**ADDENDUM 2 TO THE  
FINAL DRAINAGE REPORT  
FOR  
HOMESTEAD AT STERLING RANCH FILING NO. 2**

**EPCD File No. SF-19-004/CDR-20-012**

**December 27, 2022  
Project No. 25188.29**

**Prepared By:  
JR Engineering, LLC  
5475 Tech Center Drive, Suite 235  
Colorado Springs, CO 80919  
719-593-2593**

Basin ID: Sand Filter - Basin X1

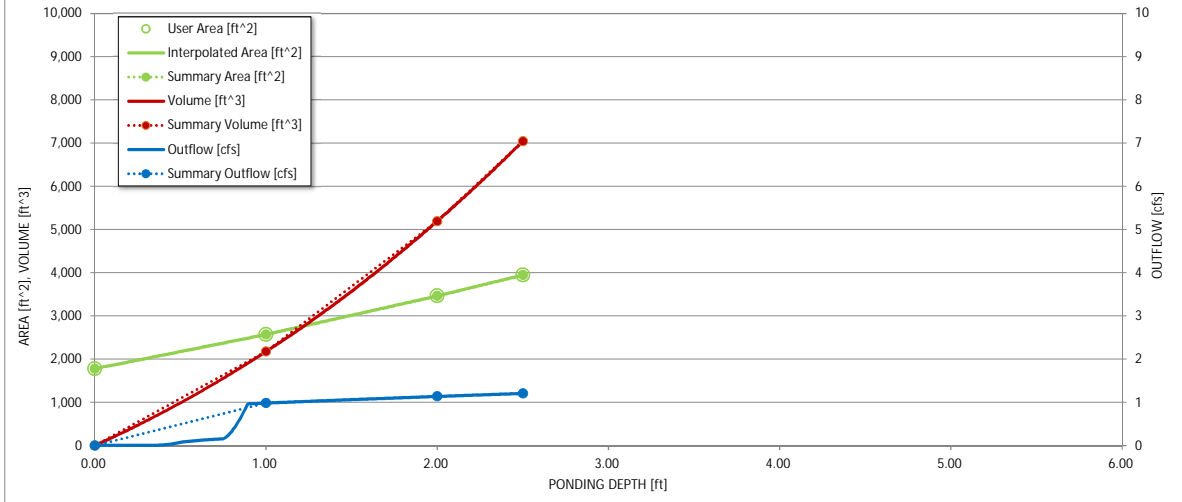
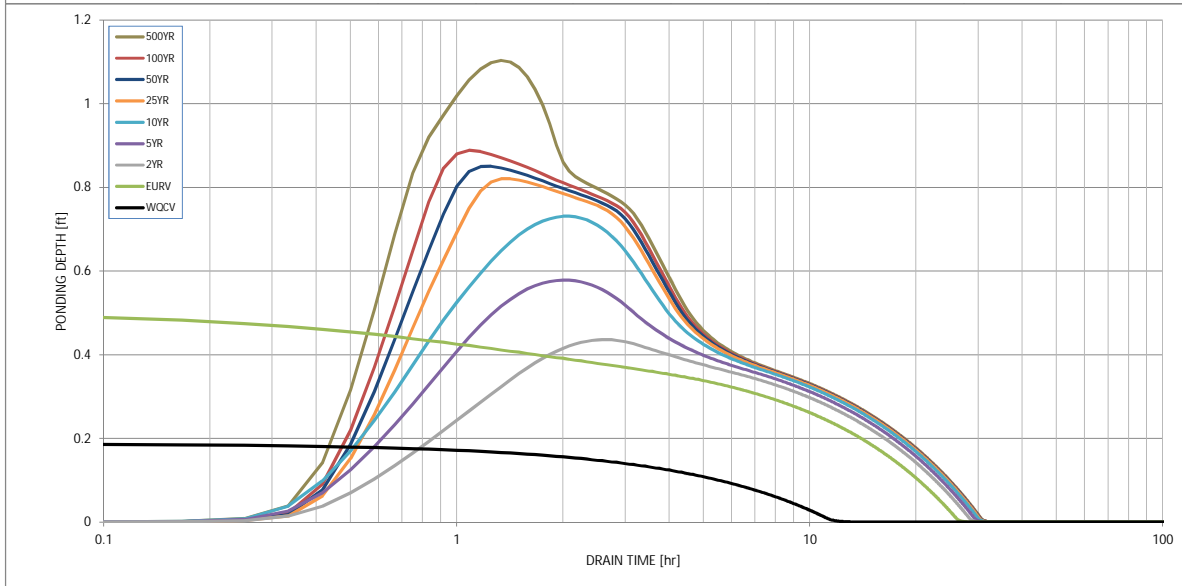
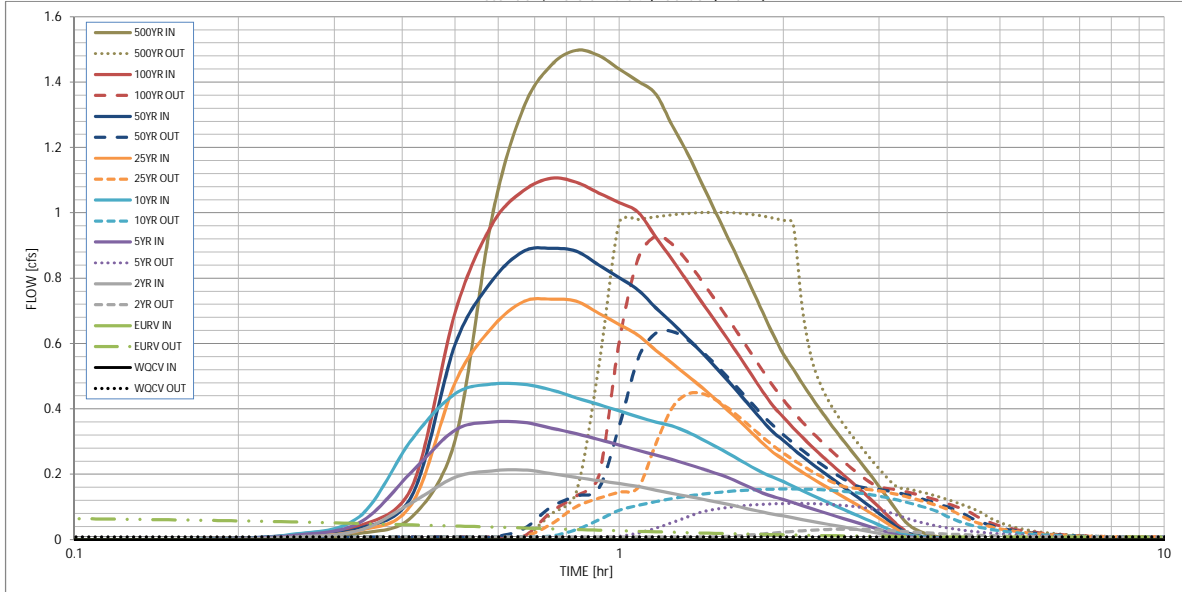
shown as 2.5ft on Sht 8 of GEC Plans and in calcs on pdf pg 15 below. Revise to remove discrepancy.

## PROPOSED DRAINAGE MAP (ADDENDUM)

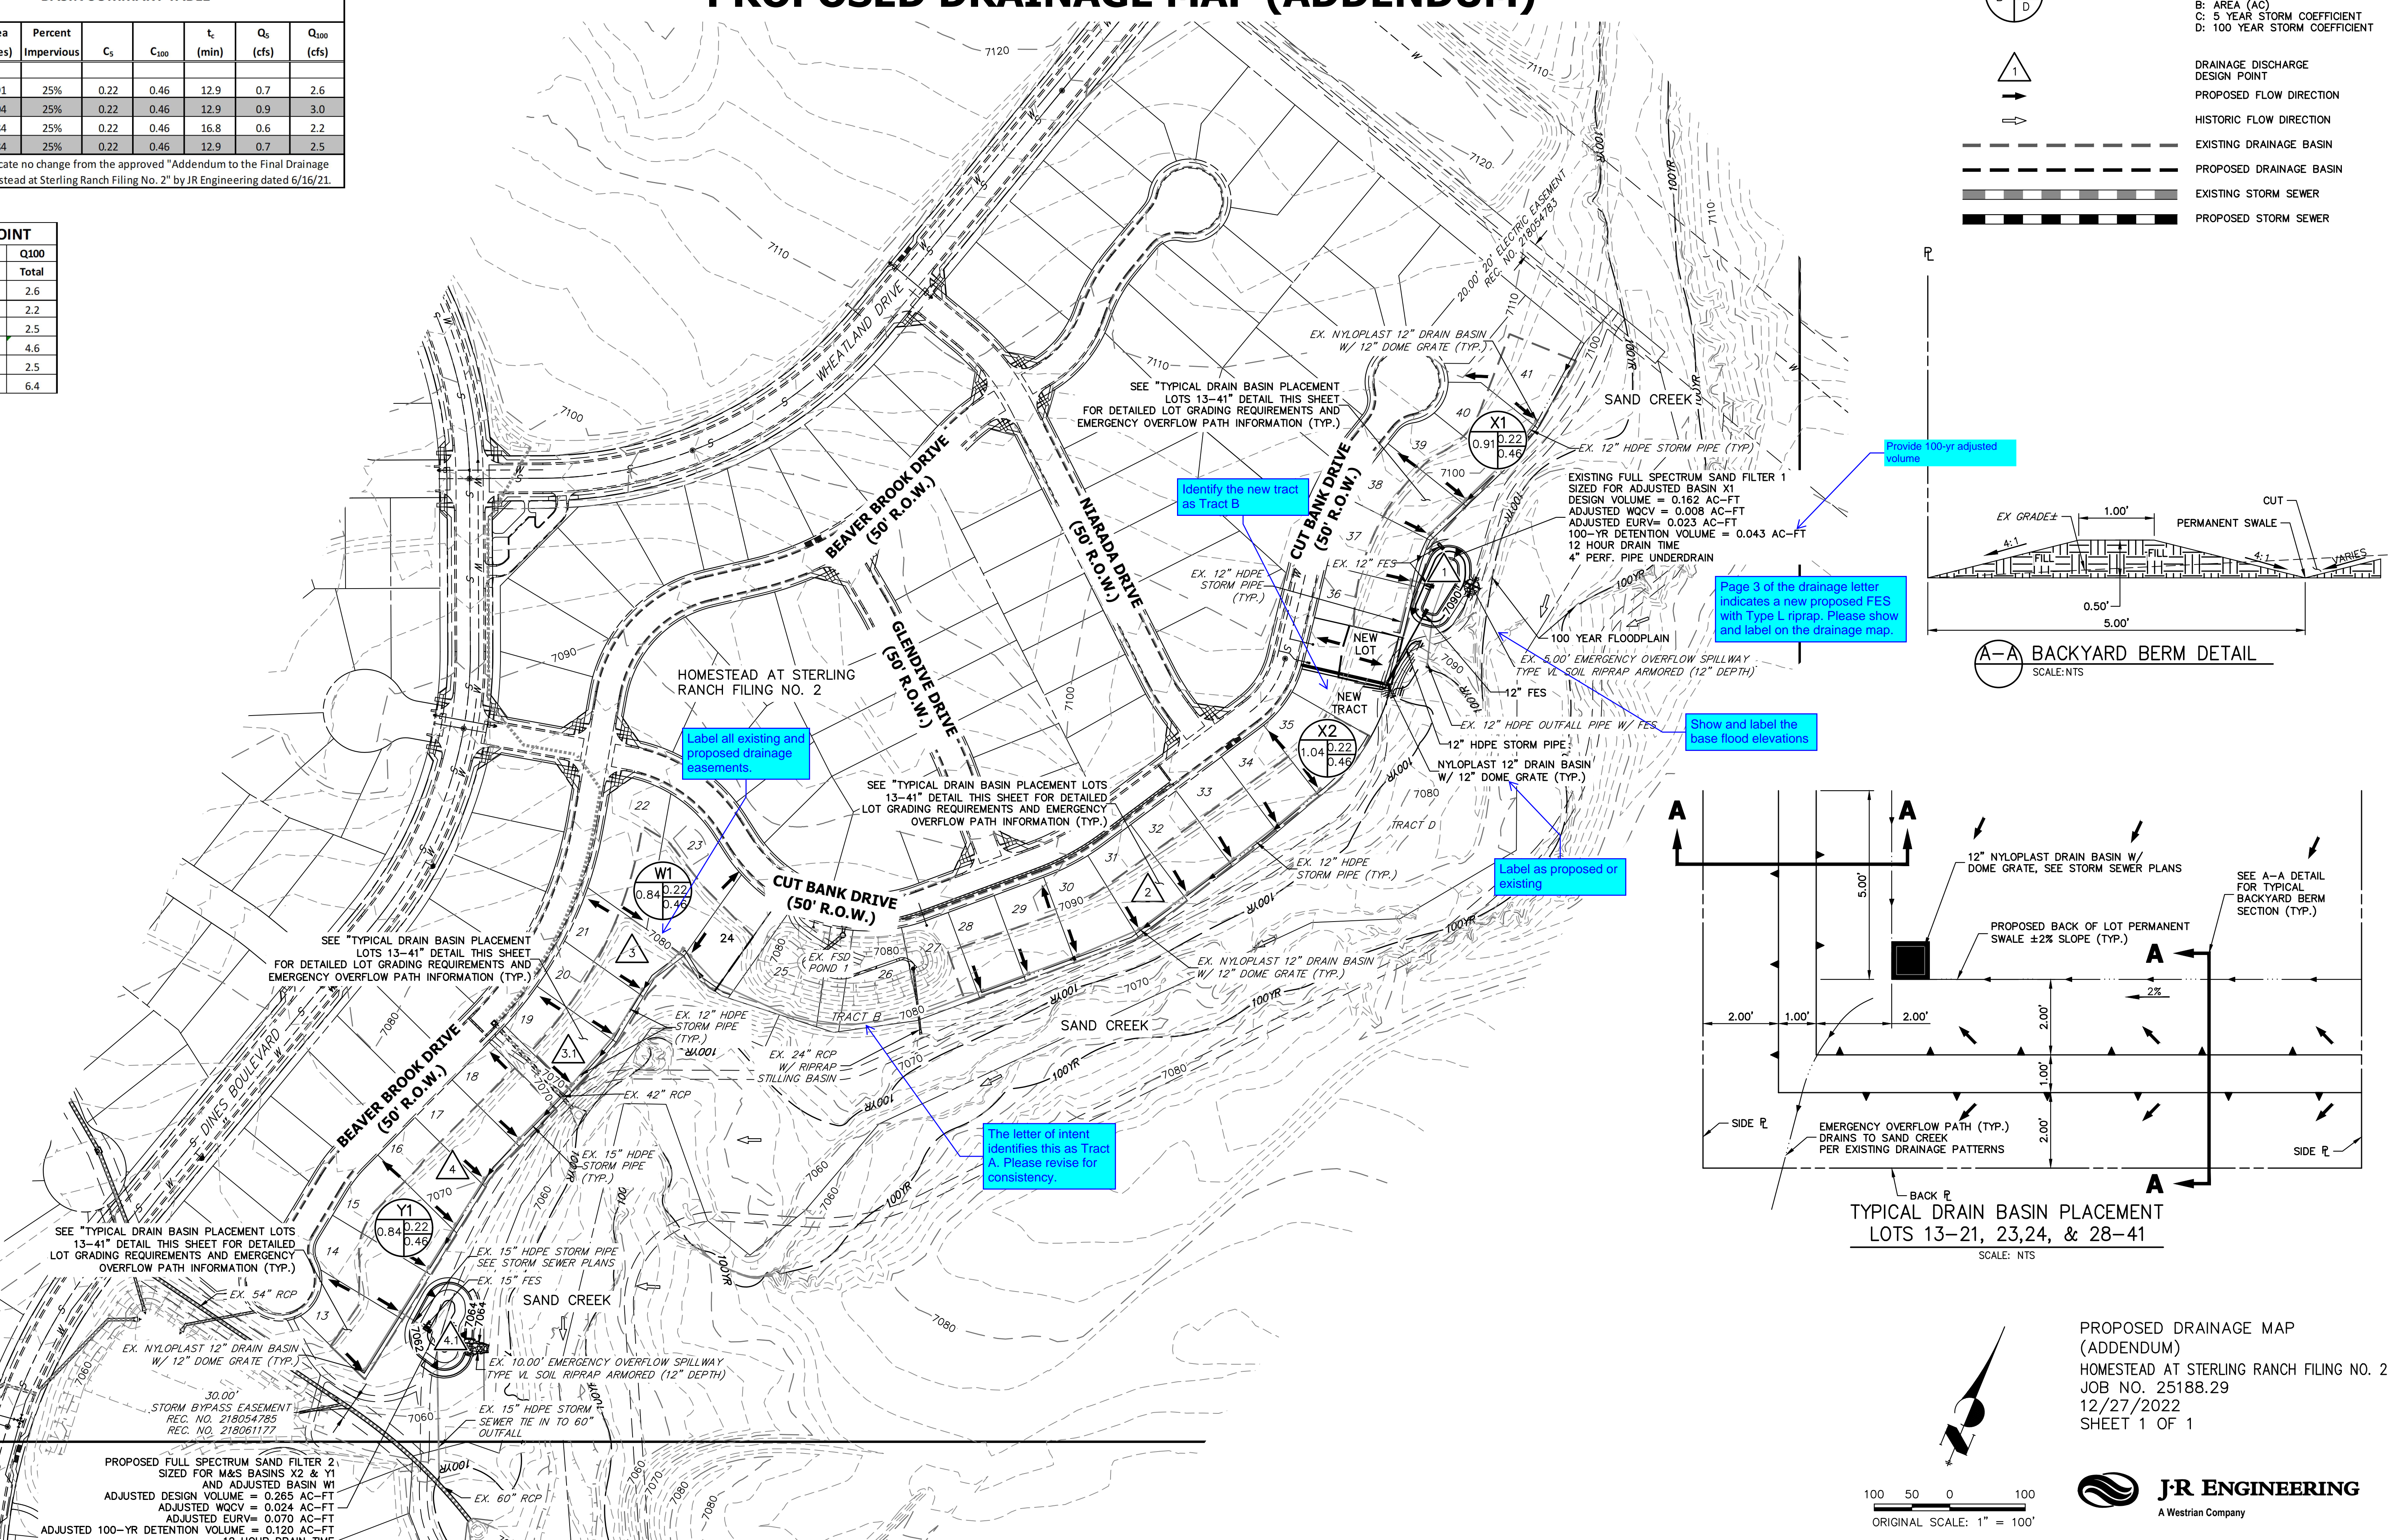
Provide 100-yr adjusted volume

Identify the new tract as Tract B

Page 3 of the drainage letter indicates a new proposed FES with Type L riprap. Please show and label on the drainage map.

Show and label the base flood elevations

Label as proposed or existing

The letter of intent identifies this as Tract A. Please revise for consistency.

Label all existing and proposed drainage easements.
